**86100B-01**

# S E R V I C E                      N O T E

## **86100B Infiniium DCA Oscilloscope Mainframe**

**New part number for A17 CD ROM Drive is 0950-4373. If replacing A17 P/N 0950-4192, requires addition of 0 ohm resistor to A15 CD ROM Adapter Board.**

Figure 1 – Location of R1 (0 ohm resistor) on A15 CD ROM Adapter Assembly

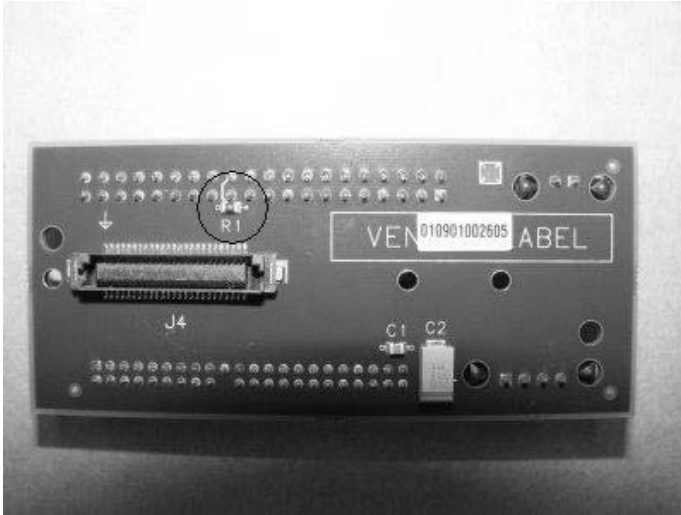
A17 CD ROM Drive P/N 0950-4192 was discontinued and replaced with 0950-4373. However, the new CD ROM drive requires a 0 ohm resistor to be added to the A15 CD-ROM

Adapter board P/N 86100-66517. If replacing CD ROM P/N 0950-4192 with P/N 0950-4373, modify A15 as follows.

1. Solder 0 Ohm resistor (P/N 0699-3574) to R1 of A15 CD Rom Adapter Board, P/N 86100-66517.
